SERVICE BULLETIN

APPLICABILITY: 2013-14MY BRZ

NUMBER: 12-156-13

SUBJECT: Rattling Sound from Seat Belt Buckle

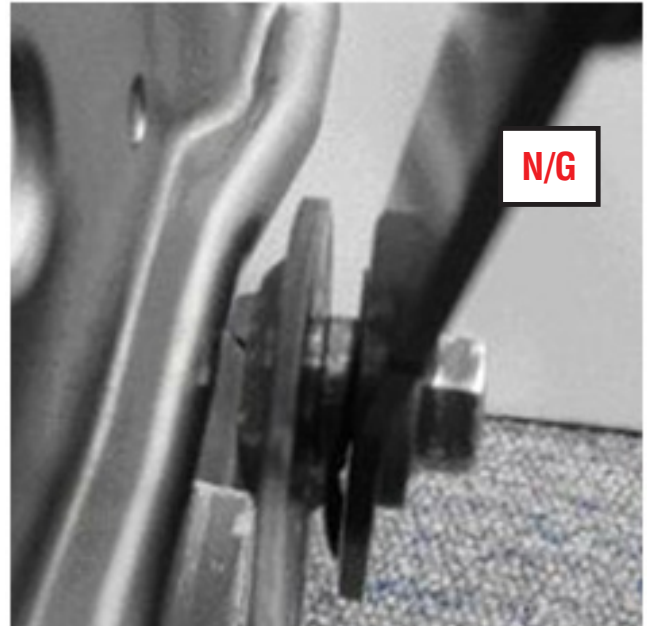
- Remove the buckle assembly from the seat then remove the toothed washer from the shouldered mounting stud. Photos of the new spring wave washer and the old toothed washer are provided for reference below.

NEW p.n. 64168CA200, Spring Wave Washer

OLD toothed washer

The new spring wave washer is available by ordering part number 64168CA200.

- Put the new spring wave washer onto the shoulder of the mounting stud in place of the removed toothed washer.
- Re-install the buckle assembly onto the mounting stud making sure the spring wave washer stays on the shoulder properly as shown in the photo below, left. The photo below, right shows the spring wave washer unseated from the mounting stud shoulder.

- Install the retaining nut and torque to 42 +/- 8.4 Nm (31 +/- 6.2 ft. lbs.).
- Reinstall the seat assembly.
- Road test the vehicle to confirm the rattling sound has been repaired.
